RotorSport UK Ltd

Service Bulletin

SB No.: 043 Iss1	CCAR No.: None	Classification:
Aircraft type & model (applicability) RotorSport UK Calidus	Aircraft serial Nos. effected RSUK/CALS/004 onwards!	OPTIONAL or RECOMMENDED or MANDATORY

CAA BCAR A3-7 Authorised Person or Pilot/Owner to certify that the work is completed by writing 'SB-043 Calidus after-muffler clamp improvement incorporated' in the aircraft logbook white pages, and record the action in the pink pages entitled 'Aircraft Modifications'. Both entries must be signed by the CAA Authorised Person or Pilot/Owner together with their CAA Authorisation number or Pilots licence number

Original installation without silicone rubber strips.
Note the wire-locking fitted through the bracket and the holes in the clip

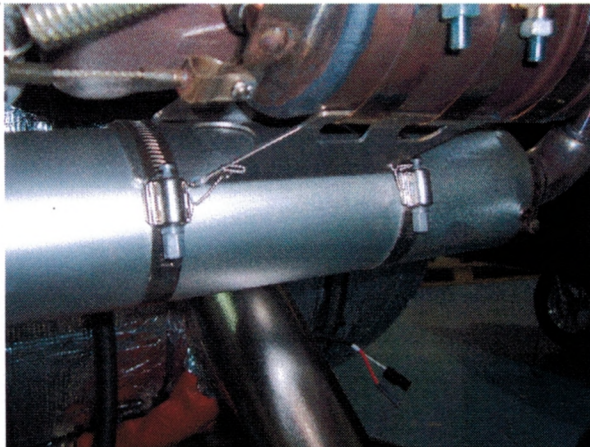
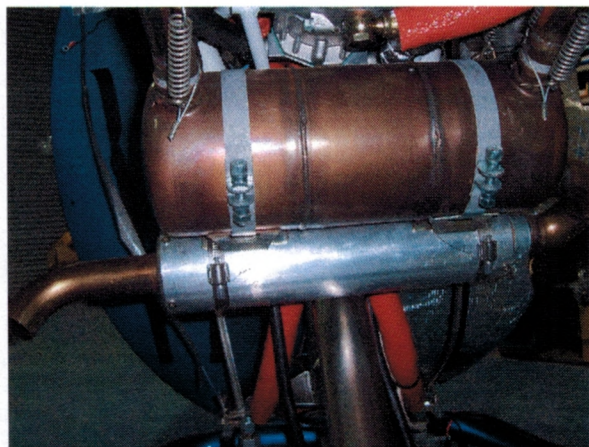
Calidus aircraft after S/no 004 (both 912ULS and 914UL-engined variants) have a transverse after-muffler clamped under the main silencer by means of a stainless-steel saddle/tension-band arrangement. The tension bands may fail due to the thermal stresses in the mounting system (but the aftermuffler will be retained by its pipe-clamp and wire-locking). A silicone strip may be fitted under each tension-band to reduce these stresses and prevent band failure.

- 1) Gaining access through the rear aperture of the engine cowlings note the arrangement of, then cut-away the wire-locking retaining the two tension bands
- 2) Unscrew, separate and remove each band.
- 3) Loosely fit new bands then position a rubber strip centrally under each band either side of the saddle lugs. Tighten each band firmly but not such that the rubber is extruded from underneath the band.
- 4) Reinststate the wire-locking
